Modification Notification

Date: Aug. 3 2021
 Ref. No. FE2-L-2108001 (1/1)

Part Number	A6T and A6S-H series
Subject	Change of slider material
Spec. No. in customer	-
Spec. No. in Omron	-

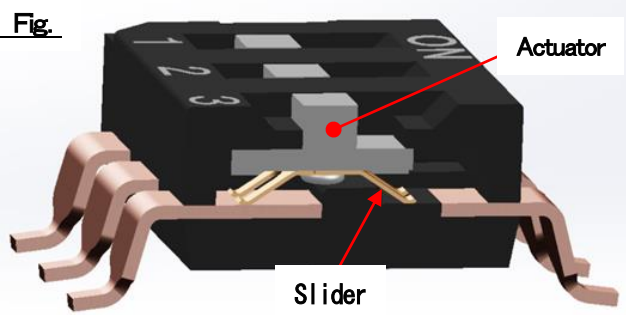
Before Modification	After Modification
<p>Material of Slider : Beryllium copper</p>	<p>Material of Slider : Copper alloys</p> <p>A6T and A6S-H are used same slider. The plating of contact surface is not changed.</p>
<p><u>A6S-H Fig.</u></p> 	
<p>Reason:</p> <p>Change to the Beryllium-less alternative material because of hard to purchase of Beryllium copper.</p>	
<p>Modification Date: As of production on July 2021.</p>	
<p>Confirmation</p>	
<p>Attachment:</p> <p>Nothing. Would you contact us when you have request?</p>	
<p>Note:</p> <p>Product specification and outline drawing are not changed.</p>
